CITY OF ALBUQUERQUE

December 7, 2022

Re: Take 5 Express Car Wash
98th St. and Sage Rd. SW
Traffic Circulation Layout
Engineer's Stamp XX-XX-XX (M09-D035)

CIRCULATION PLAN

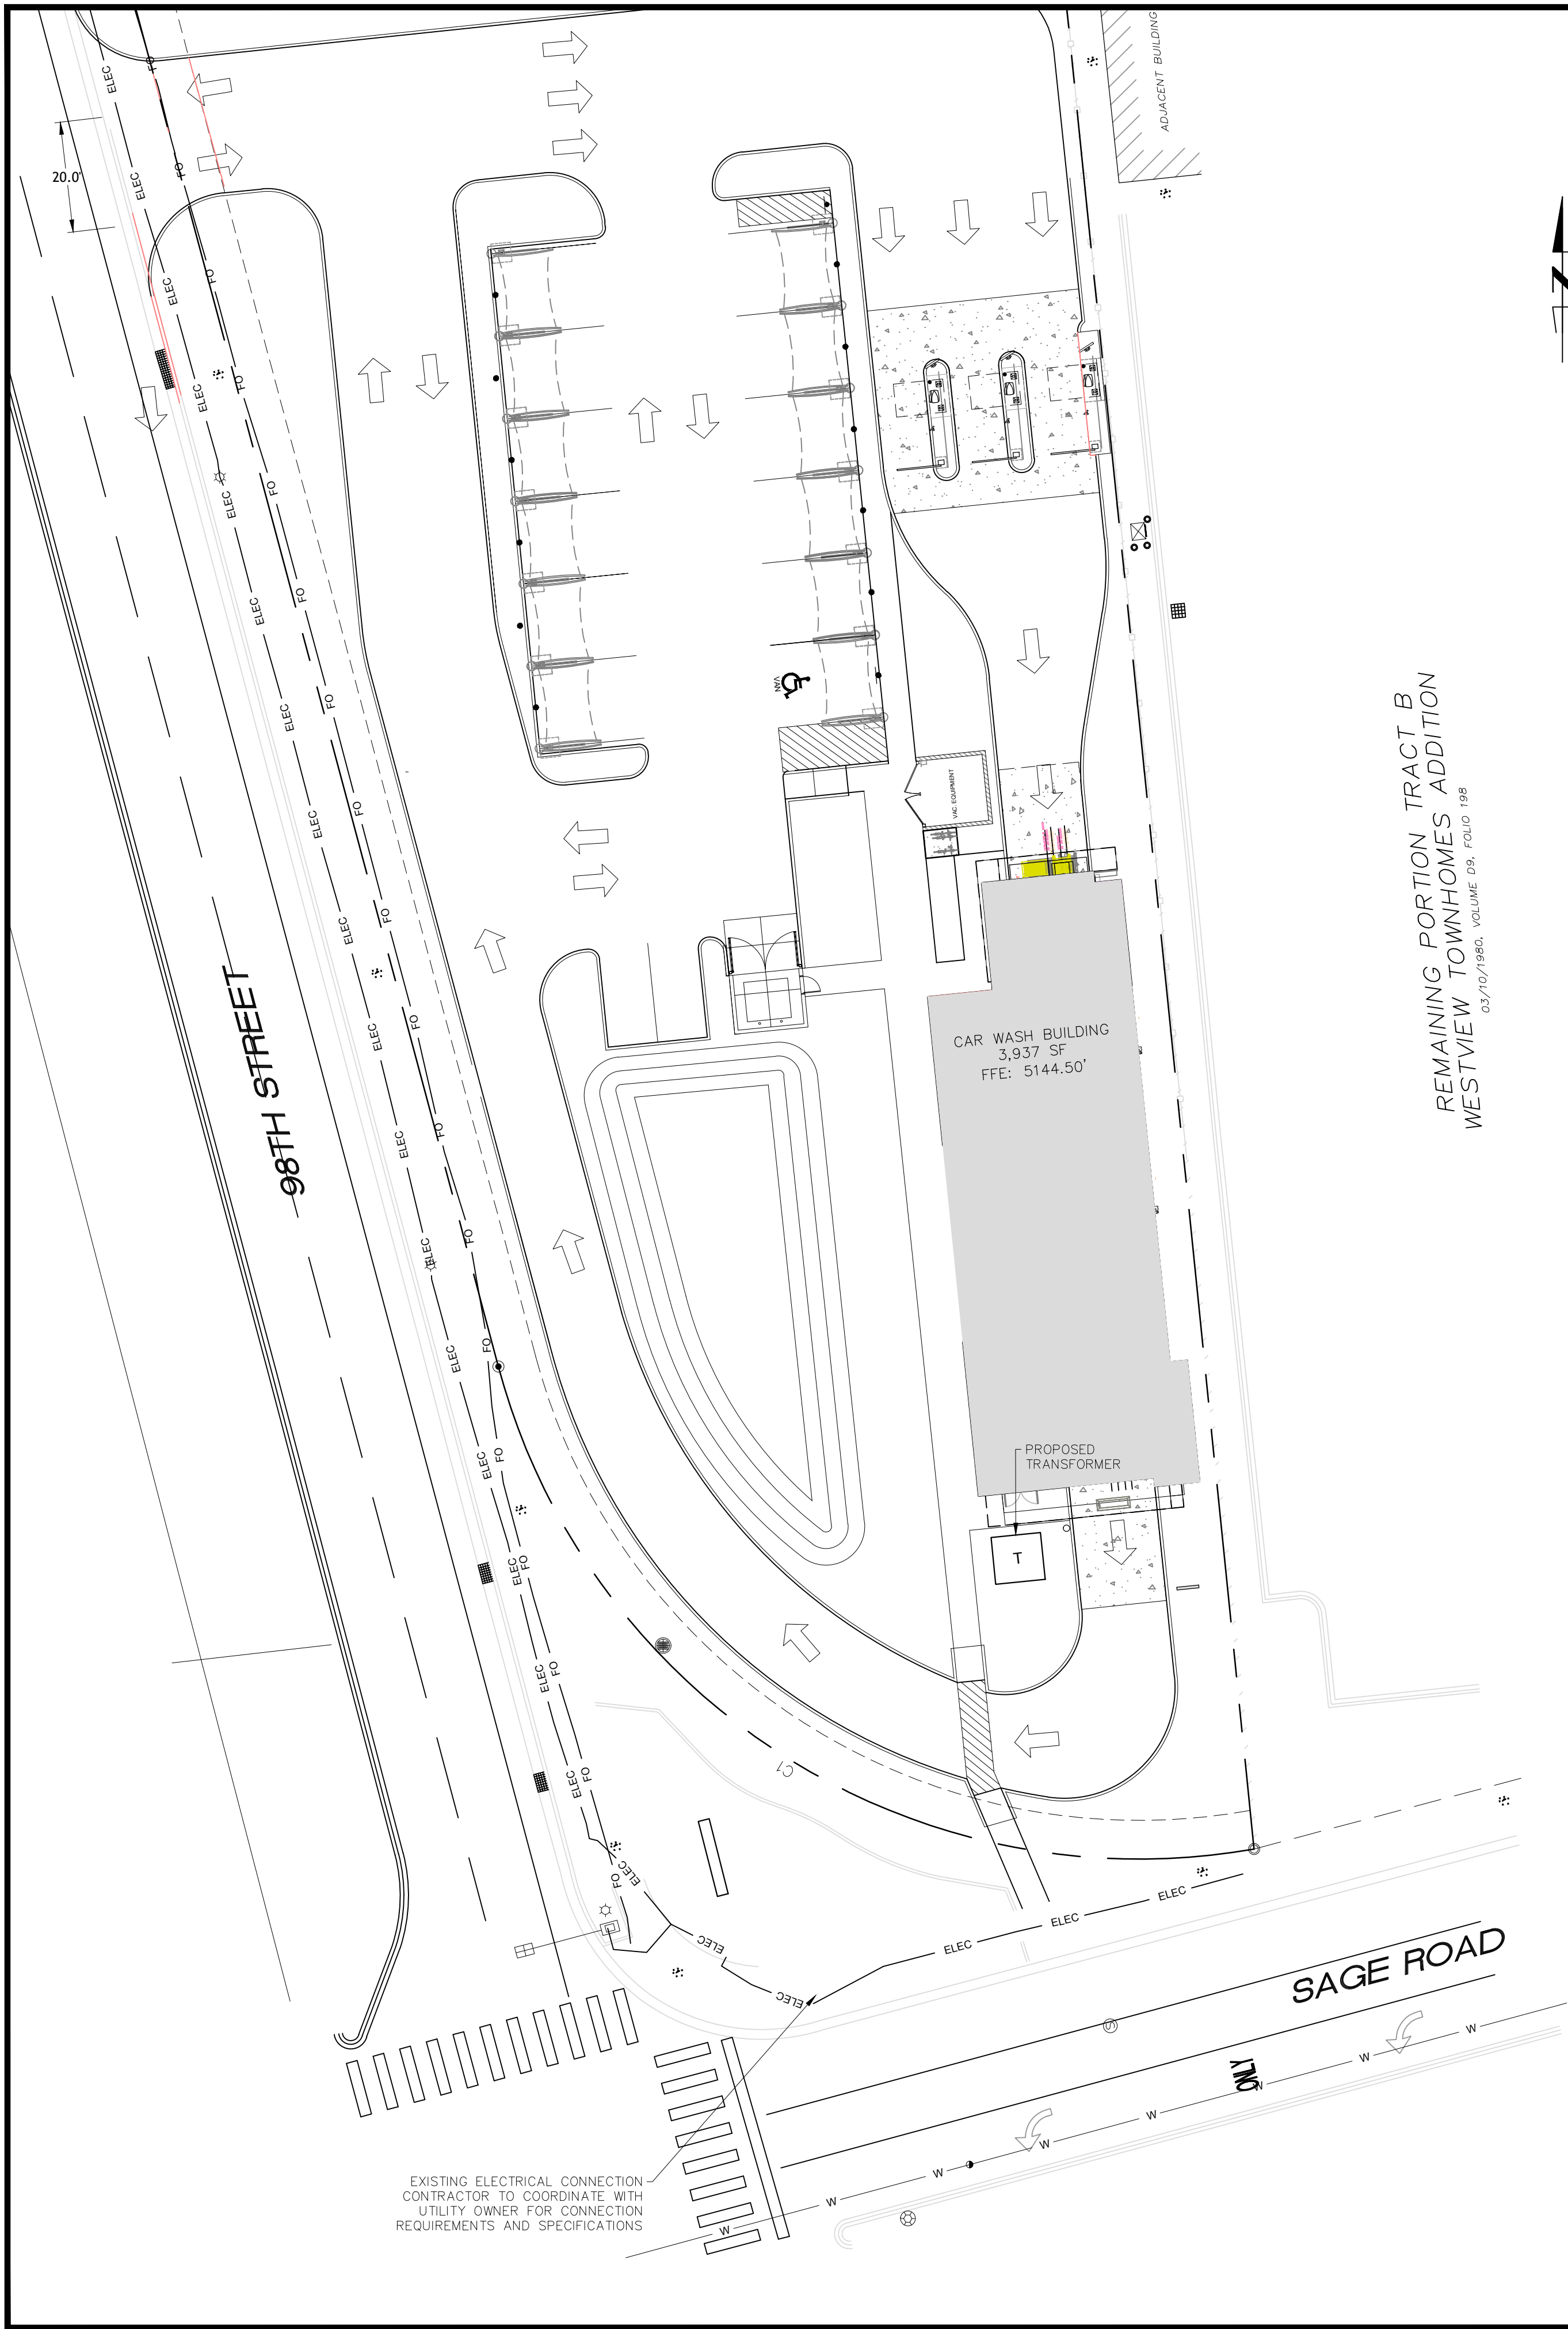
1. The traffic circulation layout must be dated by an engineer or architect licensed in the state of New Mexico.
2. Identify all existing access easements and rights of way width dimensions.
3. Identify the right of way width, medians, curb cuts, and street widths on 98th St. and on Sage Rd.
4. Clarify existing property lines and proposed property lines, and show the property line around the whole site.
5. Please show site access width and provide access design details (reference COA std dwg 2426).
6. Maximum access width for arterial, collector, and local streets are as follows:

7. The ADA accessible parking sign must have the required language per 66-7-352.4C NMSA 1978 **"Violators Are Subject to a Fine and/or Towing."** Please call out detail and location of signs.
8. The ADA access aisles shall have the words **"NO PARKING"** in capital letters, each of which shall be at least one foot high and at least two inches wide, placed at the rear of the parking space so as to be close to where an adjacent vehicle's rear tire would be placed. (66-1-4.1.B NMSA 1978)

9. ADA curb ramps must be updated to current standards and have truncated domes installed.
10. Please show Motorcycle and Bicycle parking spaces on the site plan, and provide details.

11. Motorcycle parking spaces shall be designated by its own conspicuously posted upright sign, either free-standing or wall mounted per the zoning code.

12. The pavement marking "MC" should be shown in the opposite direction for Motorcycles entering the parking space.
13. All bicycle racks shall be designed according to the following guidelines:

14. Bicycle racks shall be sturdy and anchored to a concrete pad.
15. A 1-foot clear zone around the bicycle parking stall shall be provided.
16. Bicycle parking spaces shall be at least 6 feet long and 2 feet wide.

17. Show all drive aisle widths and radii. Some dimensions are not shown.
18. The minimum drive aisle dimensions are shown below

19. List radii for all curves shown; for passenger vehicles. Radius for delivery trucks, fire trucks, etc. is 25 ft. or larger.
20. Per the IDO, a 6 ft. wide ADA accessible pedestrian pathway is required from the public sidewalk to the building entrances. Please clearly show this pathway and provide details.
21. Per DPM, a 6 ft. wide ADA accessible pedestrian pathway is required from the ADA parking stall access aisles to the building entrances. Please clearly show this pathway and provide details.

22. ADA accessible pedestrian pathway should not be placed behind parking space or adjacent to a vehicular way. Vehicle and pedestrian/wheel chair conflicts should be avoided as much as possible.

23. Refuse vehicle maneuvering shall be contained on-site. The refuse vehicle shall not back into the public right of way.; provide a copy of refuse approval.

24. Provide a copy of Fire Marshal approval.
25. It is not apparent what type of pavement surface is being proposed. A hard driving surface will be required as part of this proposed project for parking area and drive aisles.

26. All one-way drives shall have "One Way" and "Do Not Enter" signage and pavement markings. Please show detail and location of posted signs and striping.

27. The minimum drive through lane width is 12 feet with a 25-foot minimum radius (inside edge) for all turns. (A 15-foot radius can be used with an increase in lane width to 14 feet). Please dimension all lane widths and radii.

28. Please show clear sight Triangle (11 X 11) on the site plan.
29. Please specify the City Standard Drawing Number when applicable.
30. Add a note stating "All broken or cracked sidewalk must be replaced with sidewalk and curb & gutter." A build note must be provided referring to the appropriate City Standard drawing.
